AMENDMENT OF SOLICITATION/MODIFICATION OF CONTRACT		BPA NO.	1. CONTRACT ID CODE	PAGE 1	OF 1	PAGES
2. AMENDMENT/MODIFICATION NUMBER 0005		3. EFFECTIVE DATE	4. REQUISITION/PURCHASE REQ. NUMBER		5. PROJECT NUMBER (if applicable) 679-22-106

14. DESCRIPTION OF AMENDMENT/MODIFICATION (Organized by UCF section headings, including solicitation/contract subject matter where feasible.) This amendment is to post RFI responses, Drawing changes, Appendices, and an updated Wage Determination. The proposal is also extended, and the NAICS is corrected/updated to 238220 - Plumbing, Heating, and Air Conditioning Contractors - with a Small Business Size Standard of \$19 million. This amendment extends the proposal date from 4/10/25 to 4/17/25 at 1:00 PM CST. All other terms and conditions remain in effect. See Attachments to this solicitation amendment, Attachments 0005 A - 0005 H.						
15A. NAME AND TITLE OF SIGNER (Type or print)			16A. NAME AND TITLE OF CONTRACTING OFFICER (Type or print) Joyce Powers VA-VHA-RPOE-2023-0023 Contracting Officer			
15B. CONTRACTOR/OFFEROR (Signature of person authorized to sign)		15C. DATE SIGNED	16B. UNITED STATES OF AMERICA (Signature of Contracting Officer)		16C

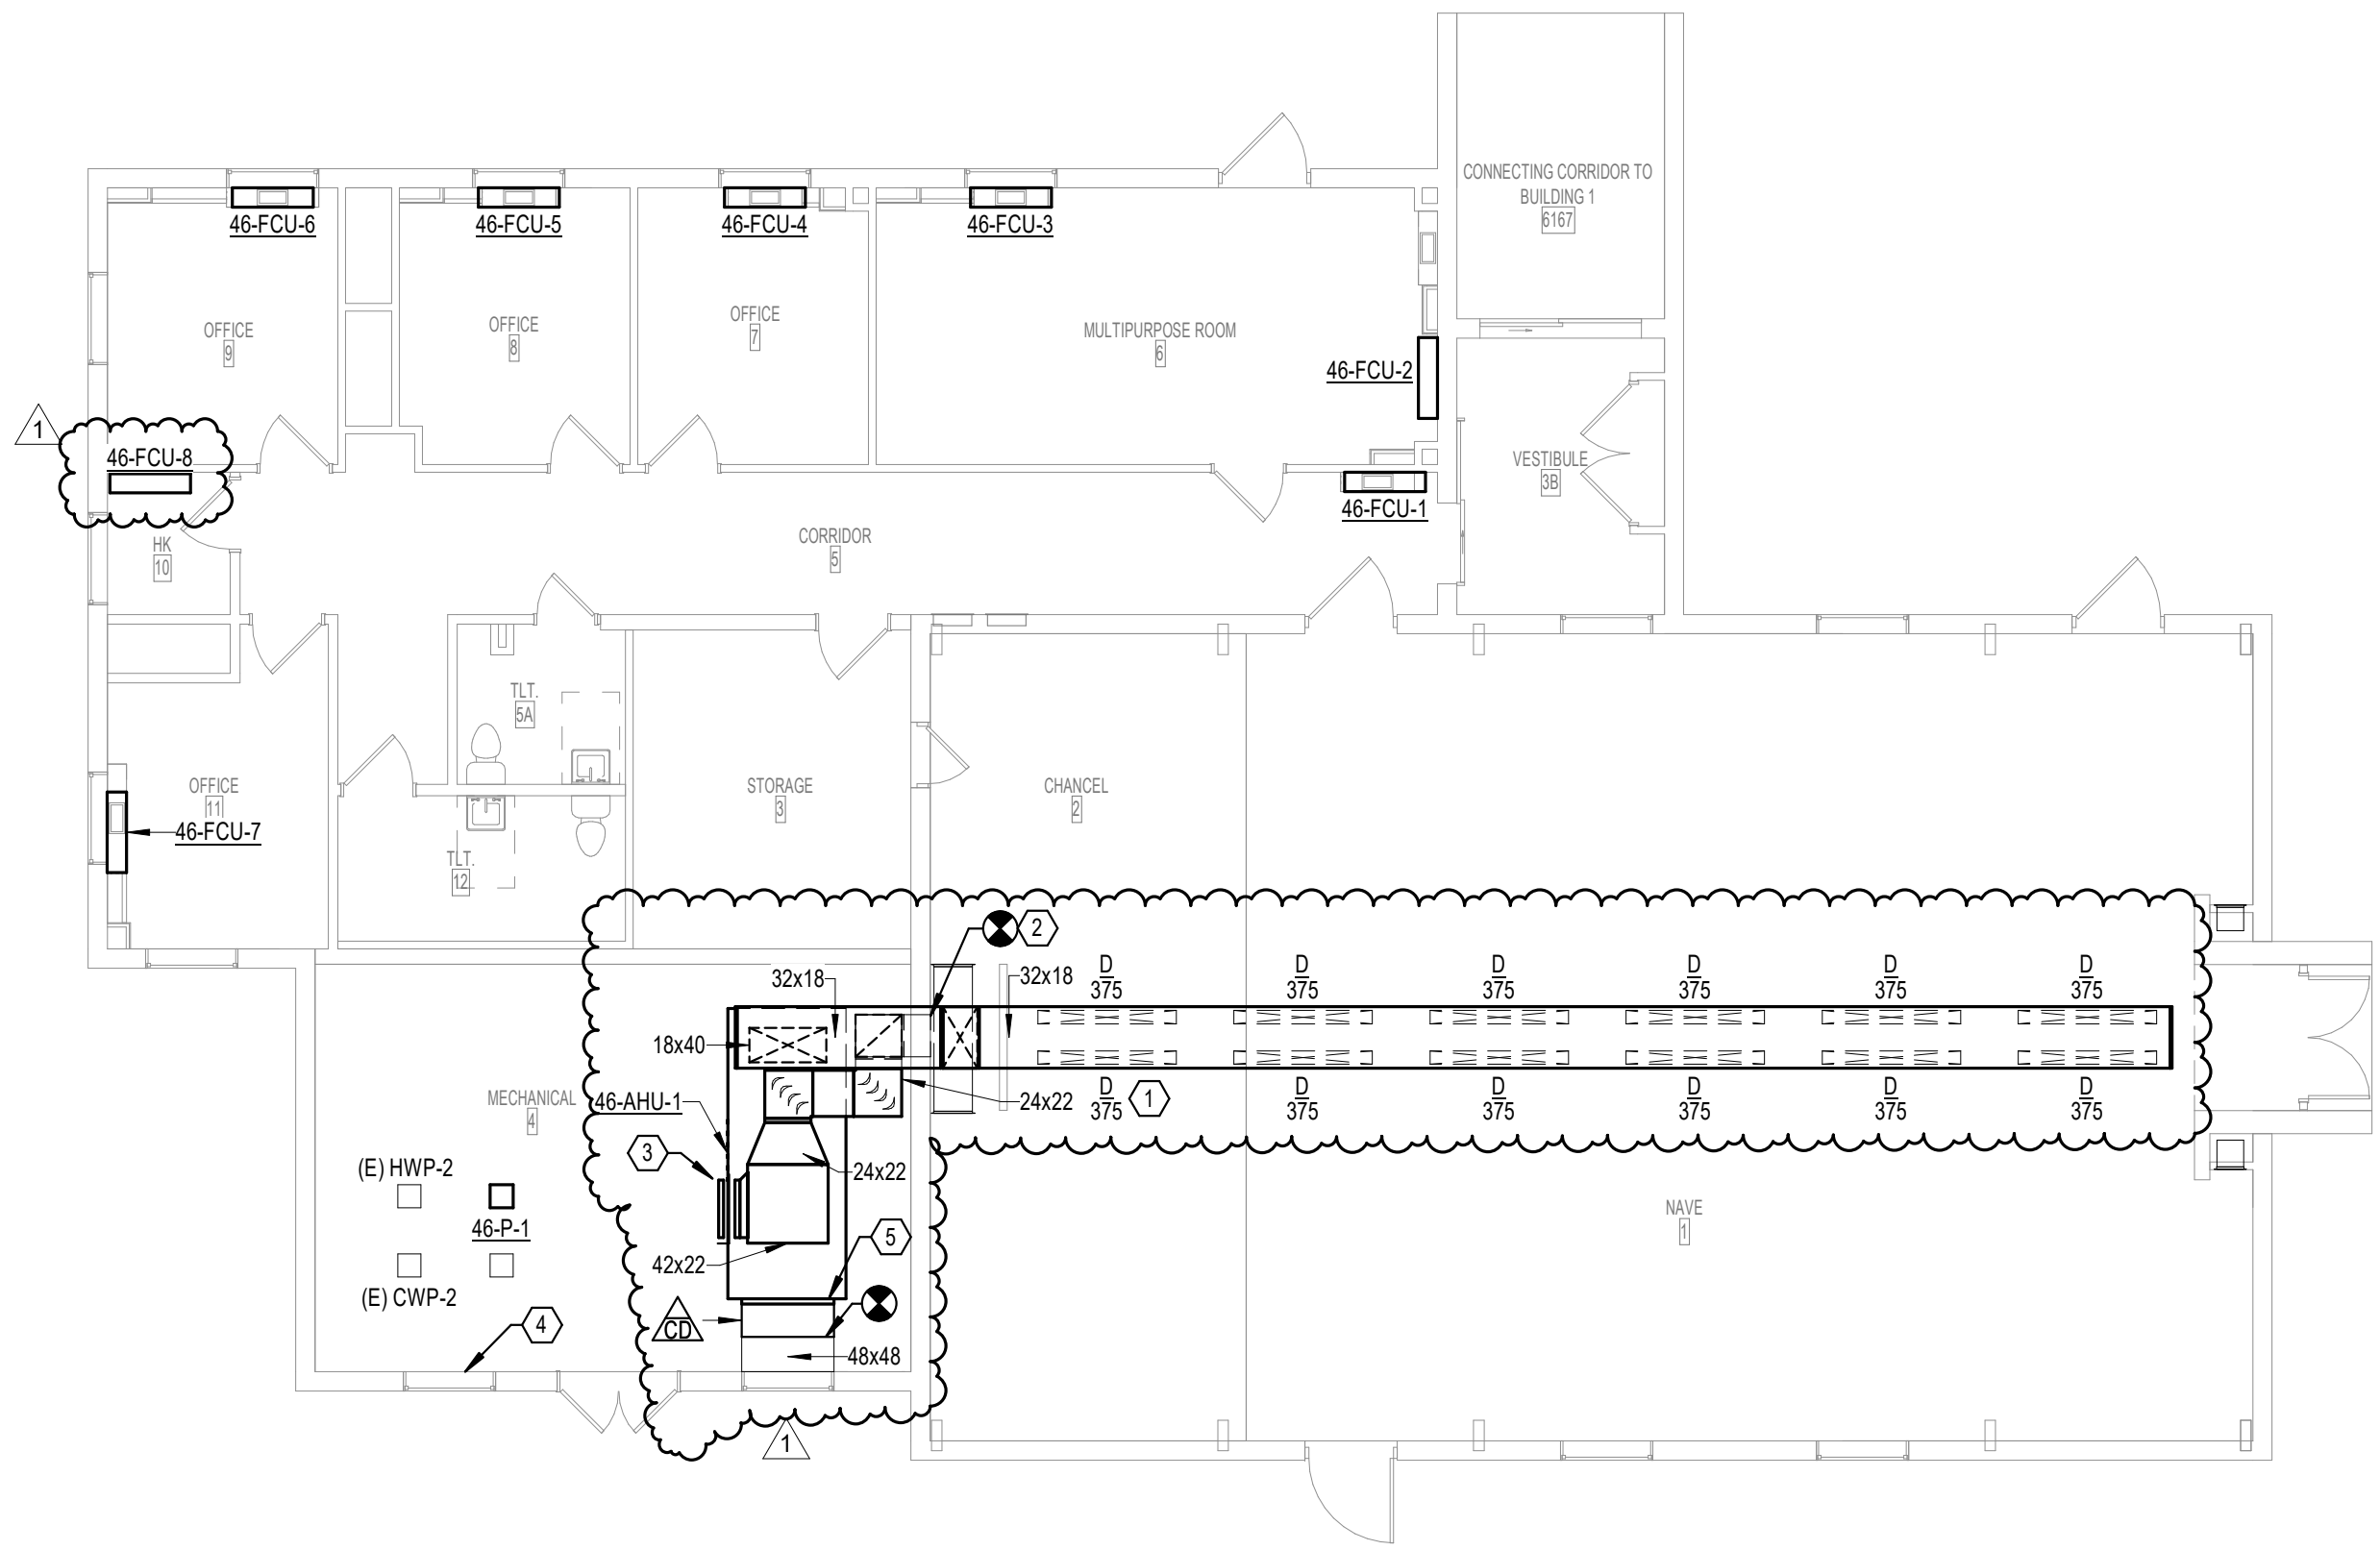
- K. Sheet EP101 (Building 46):
 1. Edited sheet notes.
 2. Corrected text overlapping.
 3. Mechanical Room 4 - Added two (2) duct mounted smoke detectors for 46-AHU-1.

11 46-AHU-1 PLAN AND SECTION DETAILS

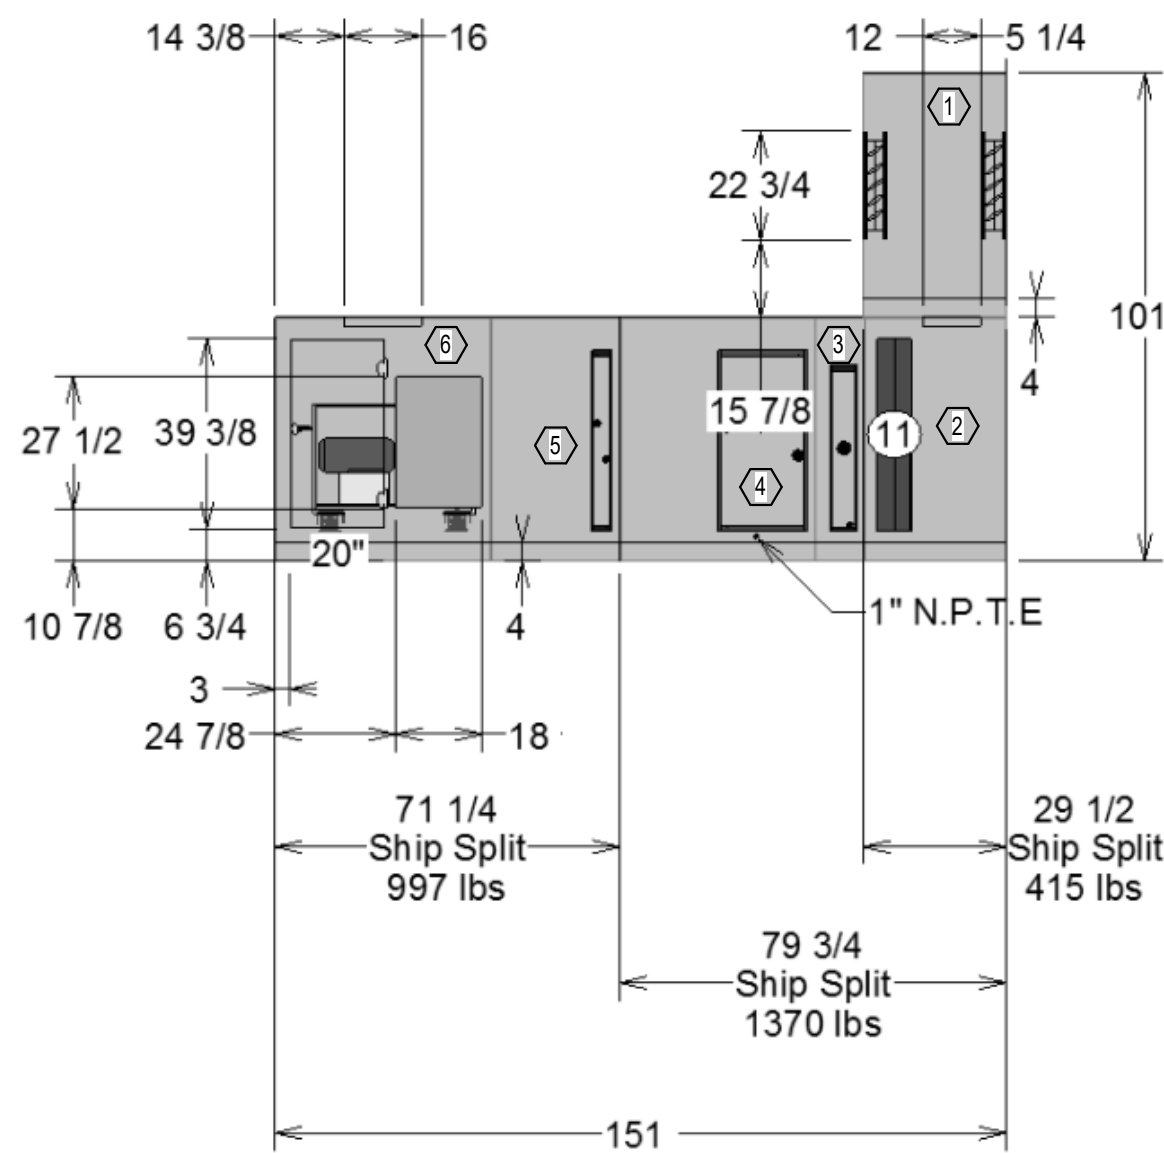
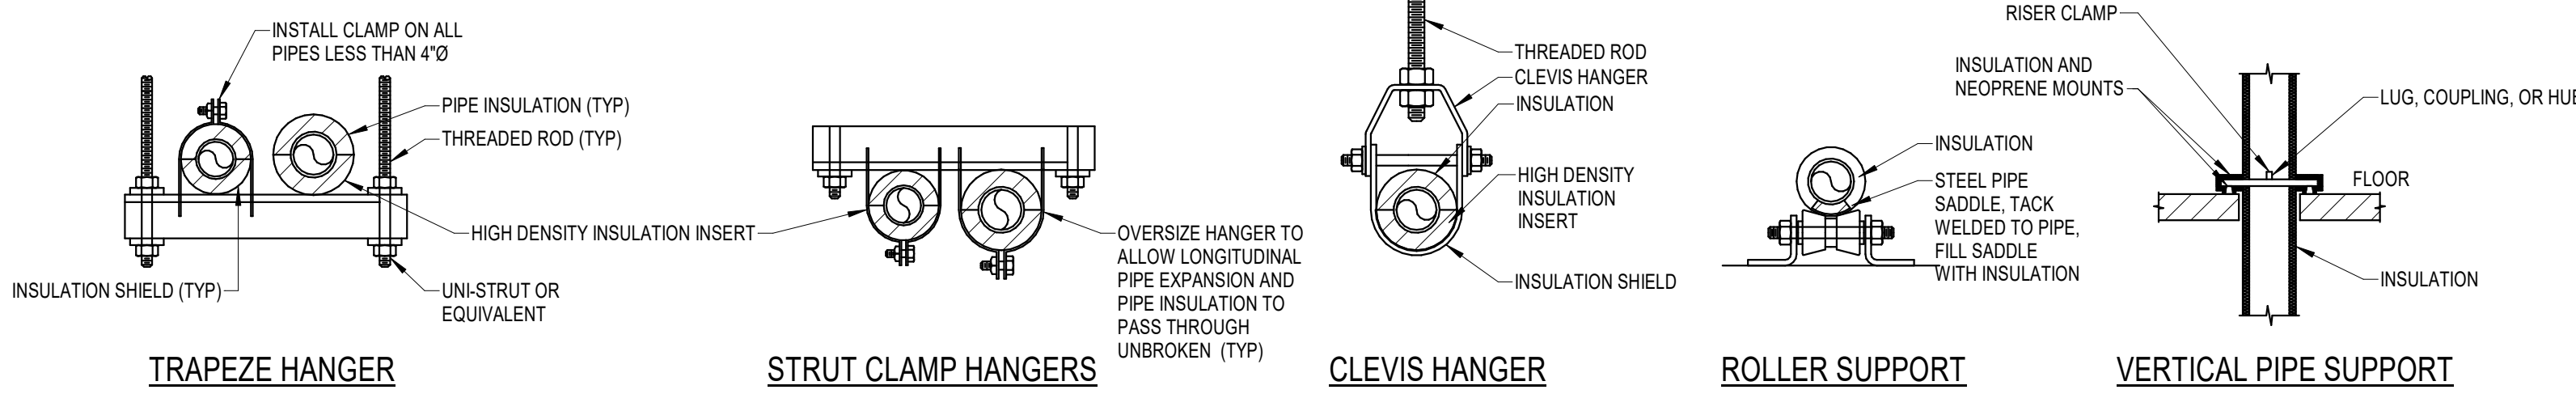
26. Can you please provide more information on the existing steam piping that we will tie-in to for 46-AHU-1? Including the size and location, including elevation, of the existing steam and condensate return piping. What is the pressure on the existing steam line that we will tie-in to? Provide the proper information showing size, type, and quantity of any new steam traps required. Is there any new work on the existing hot water to steam heat exchanger required? There is information in the spec book, but no work shown on the plans.

- a. VA Response: See amended drawing sheets.
27. What type of ceiling is present on the Ground Floor, Building 2, in Credit Union 16, Credit Union 13, Credit Union 13A, and Storage 8C?
